CHAHAL SEMI TRUCK/TRAILER REPAIR FACILITY

Re: 6100 Schooner Drive
Van Buren Township, MI
Chahal trucking Facility.

To: OHM
County review R22-0560

OHM review #6 response letter:
Revisions are designed by red revision cloud.

DETAIL FOREBAY OUTLET STRUCTURE "E"

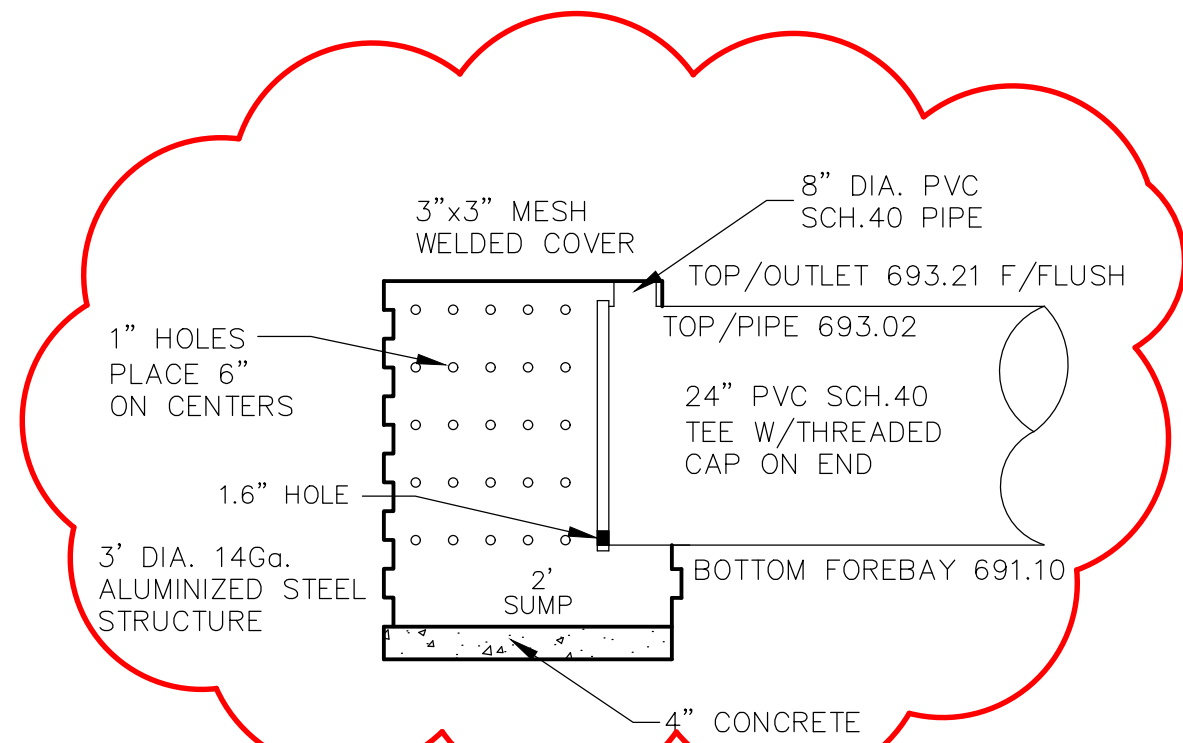
1. Noted
2. Land use summary table of cover sheet has been updated.
3. Limits of buffer strip are clearly defined with dimensions and slopes.
4. Storm Management calculations have been revised.
5. Details have been revised.
6. 24" vertical pipe has been revised to an 8" vertical pipe. An 8" vertical pipe has a capacity of of 14.88cfs as to the outlet volume as calculated, has a maximum flow of 11.28cfs. This revision will leave room within the riser for maintenance.
7. See response 6.
8. See response 6.
9. Outlet structures have been revised.
